Architectural Review Board Staff Report

Project Type: Amended Architectural Elevations

Meeting Date: October 11, 2012

Description: **Chesterfield Commons, Outlot 6 (Buffalo Wild Wings)**: Amended Architectural Elevations and an Architect's Statement of Design for a 1.747 acre lot of land zoned "C8" Planned Commercial District located on the south side of Chesterfield Airport Road, east of the intersection with Boones Crossing.

EXTERIOR ELEVATIONS

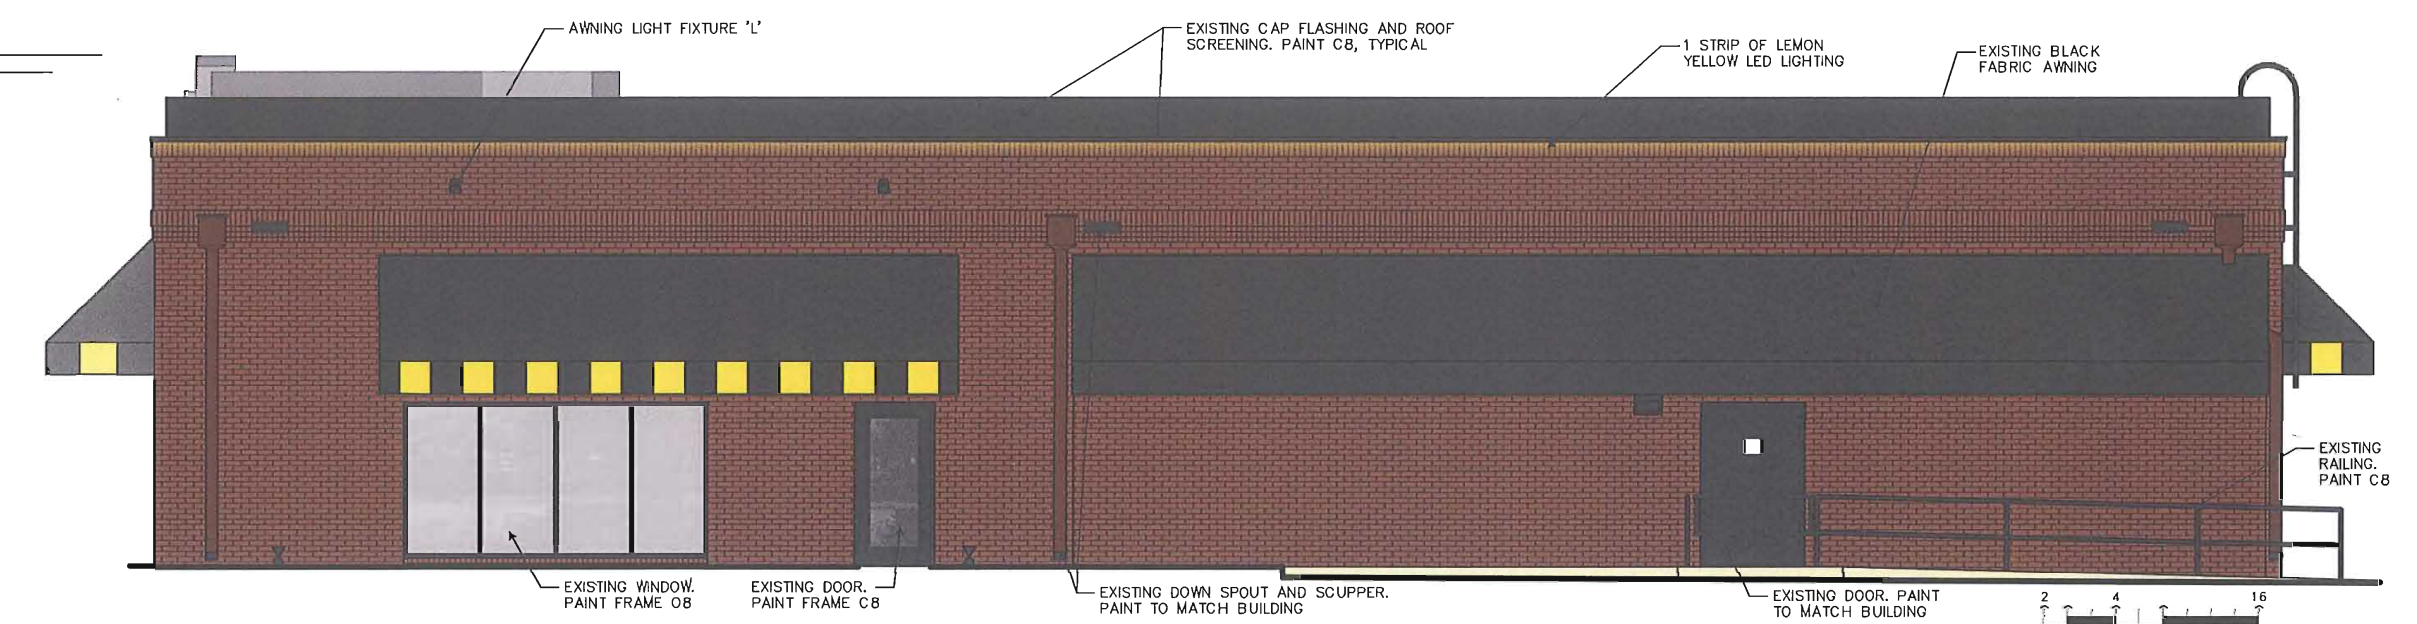
The proposed changes to the building include removing the wall with the sloped metal roof, on the west elevation, and replacing it with a new patio with railing and a metal canopy. The new exterior wall along the patio will match the existing brick color on the building and the proposed roof, columns, and railing will be painted black. The face of the metal canopy roof will be black and yellow alternating accent colors.

The front entry structure will remain the same, but the brick façade will be replaced with EFIS. The black EFIS panel on the top of the front entry is proposed to serve as a background for the wall sign. The existing awnings on the entry will be removed and replaced with a black metal overhang.

The new exterior wall for the covered patio will match the existing brick and a black railing will be added to enclose the seating area. The existing green sloped metal roof will be replaced with a black metal canopy and the existing metal roof on the front of the building will be painted a matching black as well.

SPECIFICATIONS
ONE(1) ROW OF LEMON YELLOW
SLOAN BRAND LEDStripe
(YELLOW POLYCARBONATE LENS / WHITE LEDS)
PART # 701189A-LY

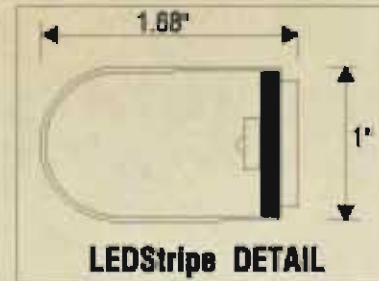
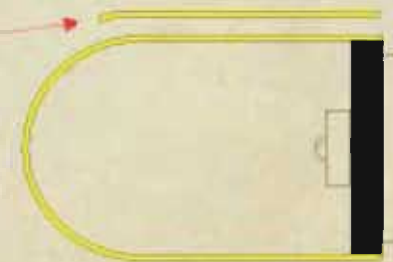
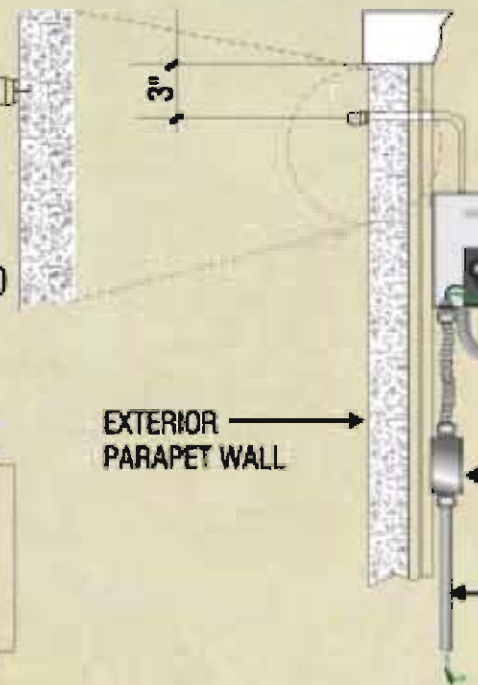
There is existing green neon tubing along the roofline; the proposal is to replace this with a yellow LED strip with a top film to prevent light spill-over. The current neon tubing was approved in 2000. The City Code for lighting, adopted in 2005, prohibits the use of visible neon tubing for an architectural element but it does allow for LED technology to be used subject to City approval. This lighting is intended to be accent lighting only.
